ADDENDUM NO. 1

**INDIANAPOLIS-MARION COUNTY PUBLIC LIBRARY
SHELBY STREET BRANCH**

ADDENDUM #1

Date of Issue: April 2, 2011

**DEMOLITION
FLOOR PLAN**
AD101
PROJECT NUMBER: 11008

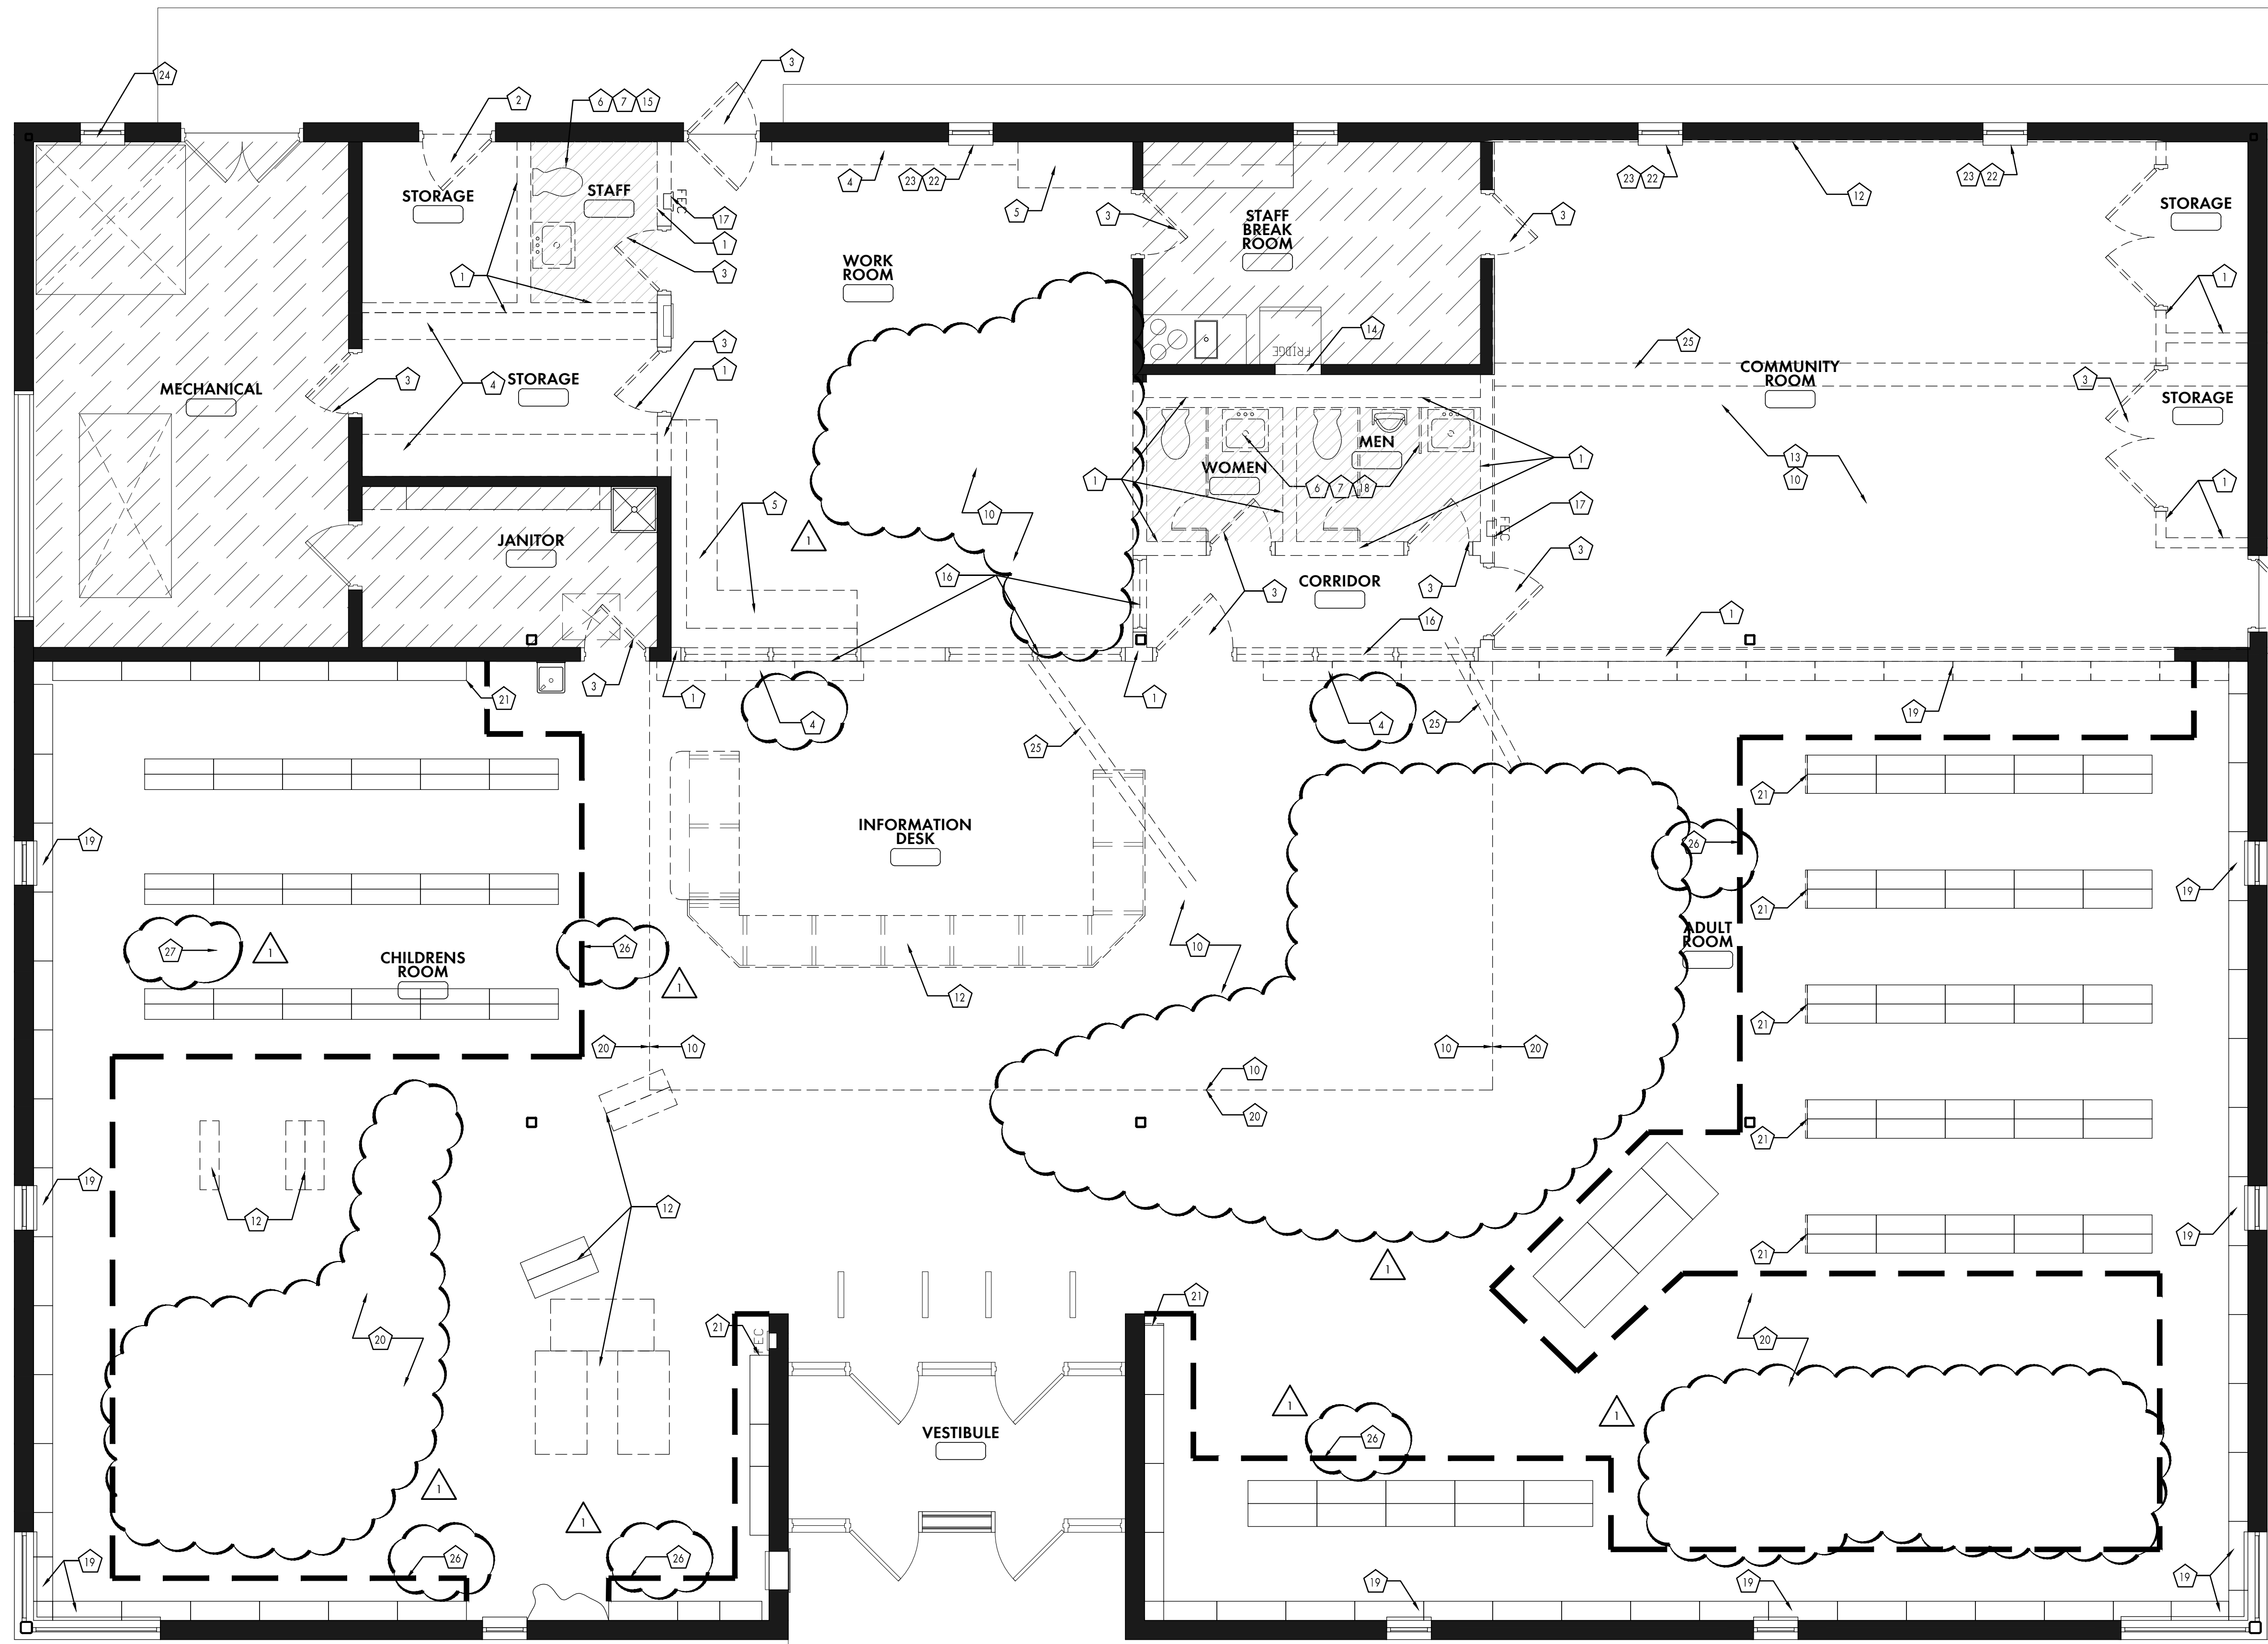
Item-6 AD101 –Demolition Floor Plan (reissued)

- A. Revise Plan Demolition Note 8 & 9 as follows:
“NOT USED.”
- B. Indicate shelves and books to be shrink wrap for protection.
- C. Indicate area for owner equipment storage.
- D. Revise floor plan to show existing conditions at project start.
- E. Indicate items covered in note 4.
- F. Revise Note 20 to indicate existing floor to be protected.

Item-14 Will you clarify that the Contractor is to wrap up / protect the existing book collection? Can you clarify which collection area or units will be remaining in the existing building that we will need to protect?

- Item-19 Please provide most recent Wage Determination rates to be used for bidding purpose.**
- A. Refer to attached Wage Determination rates.
- Item-20 We see note call out for Note 8/AD101. Please clarify area(s), if any where Note 8 applies?**

- A. Not used.
- Item-21 We see note call out for Note 9/AD101. Please clarify area(s), if any where Note 8 applies?**
- A. Not used.
- Item-22 We see note call out for Note 4/AD101. Please clarify area(s), if any where Note 8 applies?**

- A. Refer revised AD101 for location.
- Item-23 Please clarify where equipment to be turned over to owner (Note 12/AD101) is to be left and/or delivered.**

- A. Refer revised AD101 for location.
- Item-24 Please confirm that Contractor is to shrink wrap all existing shelving and books which are to remain.**

- A. Refer revised AD101.
- Item-25 Please clarify what will and/or will not be left in building after the Owner vacates the premises.**
- A. Refer revised AD101.

- Item-26 I would recommend you consider carpet protection for the Carpet to Remain (Note 20/AD101).**
- A. Refer revised AD101, note 20.
- Item-27 Floor plan note 32 indicates that the owner furnishes and installs lockers. There is the speciation section for lockers. Can you clarify who's responsible for the lockers?**

- A. Refer to revised AD101.

7. REMOVE EXISTING TOILET PARTITIONS IN THEIR ENTIRETY. PATCH AND REPAIR WALL ASSEMBLIES AS NECESSARY TO ACHIEVE NEW FINISH.
 8. NOT USED.
 9. NOT USED.

20. EXISTING FLOOR FINISH TO REMAIN.
 21. REMOVE EXISTING END PANELS.
 22. REMOVE WINDOW SURROUNDS AND PREPARE WALL FOR NEW FINISH.
 23. REMOVE WINDOW TREATMENTS.
